Re: Third Submission Review – Avelon – Framework Development Plan and Comprehensive Plan Amendment
Application Number: DA-2121-00
Case Numbers: 2018-1005-00; 2018-7004-00

Third Submission Review

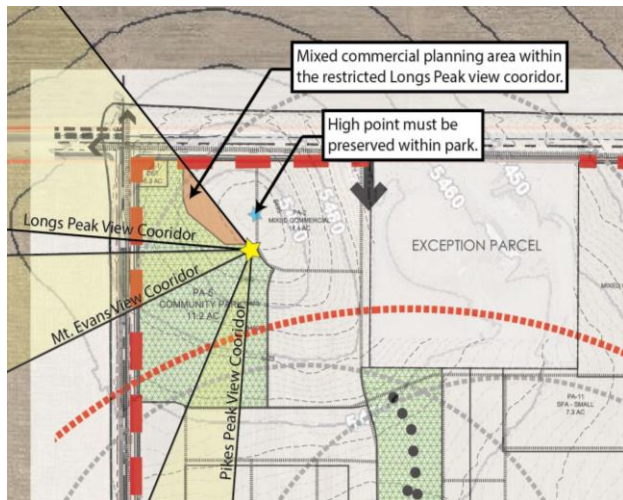
9D. The community park shown in PA-5 must encompass the high point and critical view corridors as defined by the Mountain View District and the View Corridor Analysis. As shown in the following graphic produced by PROS, there is some question as to the actual location of the high point and whether or not it's being shown preserved within the community park site.

9E. The applicant must provide new topographic data to confirm the exact location of the physical high point within the Avelon property. The location data would then be confirmed by PROS before inclusion in subsequent planning documents.

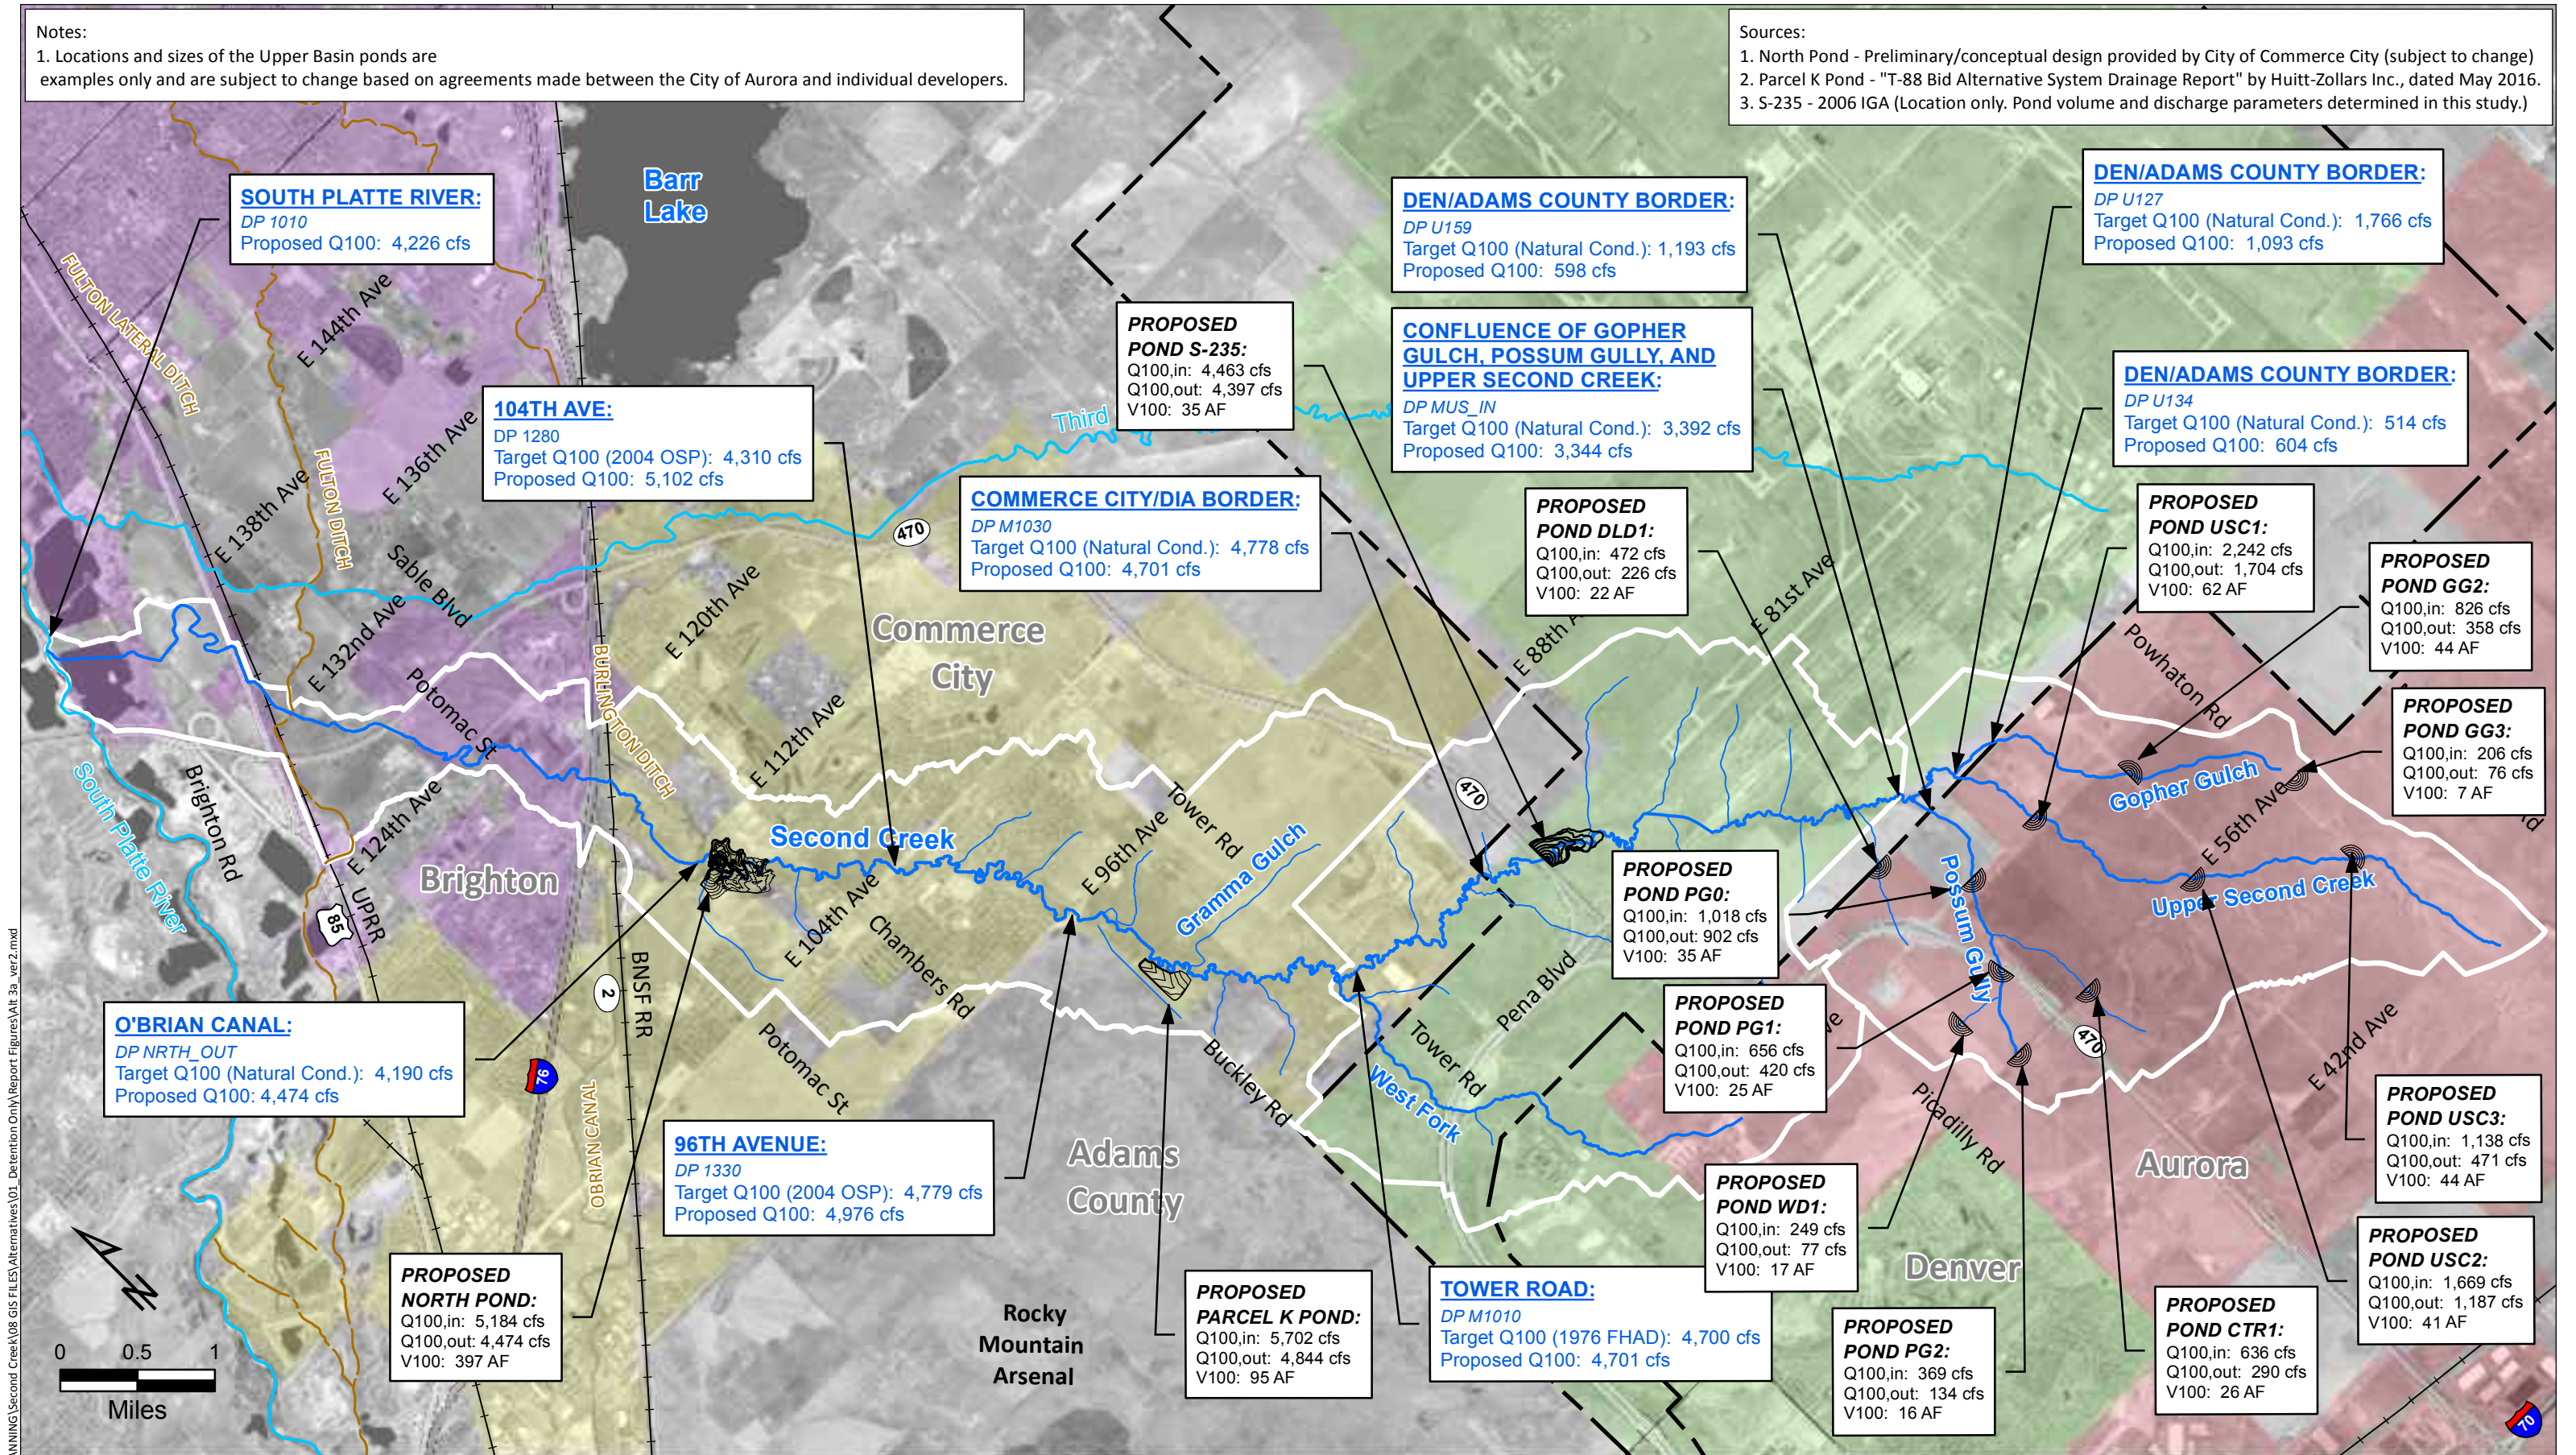
1. There doesn't appear to be any new information on this submittal specifically related to drainage. Our main concern with the development of this site is ensuring that regional detention at the upper end of Weasel Drainage is implemented in line with the recommendations with the ongoing Second Creek Major Drainageway Plan. The attached excerpt shows a detention basin on this property at the upper end of Weasel Drainage. The intent of the master plan is to limit flows to at or near natural pre-development flows along the receiving streams.
